AGENDA FOR THE CANTERBURY BANKSTOWN LOCAL PLANNING PANEL MEETING

12 April 2021 - 6.00pm

ITEM 1	229 Tower Street, Panania
	Demolition of all existing structures and the construction of a four storey shop top housing development comprising basement carparking, four ground floor retail/commercial premises and 34 residential units at the upper levels.
FILE	DA-1326/2015 – Revesby
ZONING	B2 – Local Centre
DATE OF LODGEMENT	4 November 2015
APPLICANT	Mr Dugald Mackenzie
OWNERS	Panania Pty Ltd
ESTIMATED VALUE	\$9,103,192.00
AUTHOR	Planning

ITEM 2	684-700 Canterbury Road, Belmore
	Proposed construction of a six storey shop top housing development comprising 39 residential units, commercial tenancy, two basement levels and associated landscape and site works.
FILE	DA-422/2018 - Roselands
ZONING	B5 Business Development
DATE OF LODGEMENT	20 September 2018 (Amended Plans received on 12 June 2019, 1 October 2019, 19 November 2019, 15 May 2020, 23 December 2020 and 26 February 2021)
APPLICANT	CD Architects
OWNERS	Chidiac Holdings Pty Ltd
ESTIMATED VALUE	\$13,000,000.00
AUTHOR	Planning

1 LEP HEIGHT BLANKET DIAGRAM VIEW 2

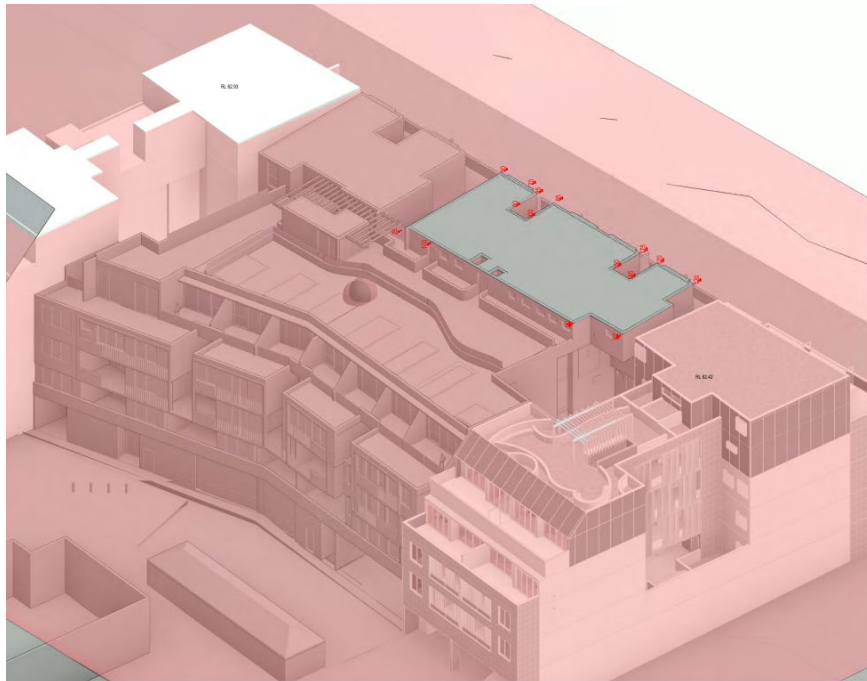
The area of encroachment onto the height control is shown in the LEP Height Blanket below.

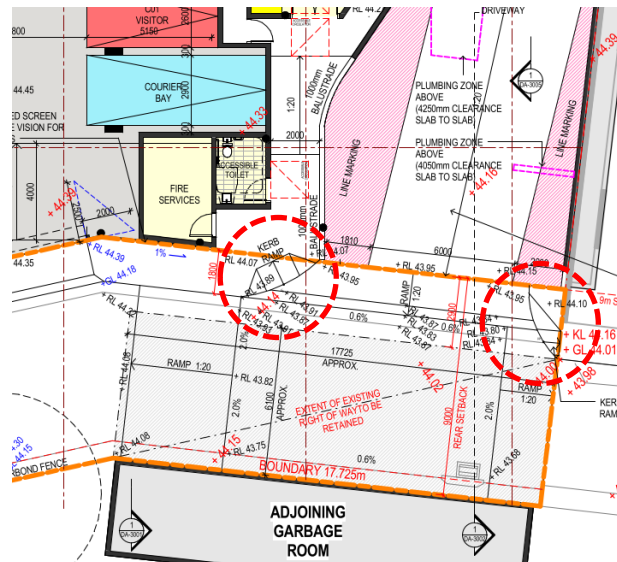
The plan shows only a pedestrian ramp on the western side, and nothing on the eastern side of the basement entry. This has been designed to avoid the conflict with the truck movements and the kerb

Given the recent fatalities of interaction between garbage trucks and pedestrians, and other vehicles in surrounding localities. A safe and equitable pedestrian pathway is required to ensure pedestrians have a safe and compliant route of travel along the footpath adjacent to the building to connect to the footpath alongside the adjacent development. This may be achieved by moving the basement accessway further to the west. However, this may impact on the required truck manoeuvring area, internal layout of the ground floor and the proposed open space area and needs to be carefully considered as part of an overall design solution.

The question about trucks entering on a slope and whether the truck will enter such that the vehicle actually breaches the 3.8m.

The appropriate longitudinal clearance profile to ascertain this have not been provided for assessment.

Boundary

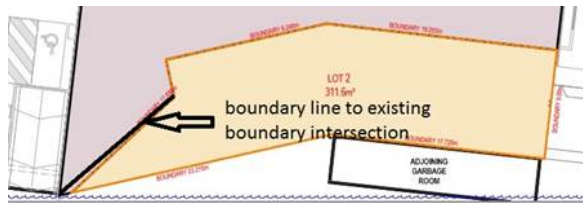
The boundary of the road dedication shall extend to the existing south west boundary corner of the site, see black line above
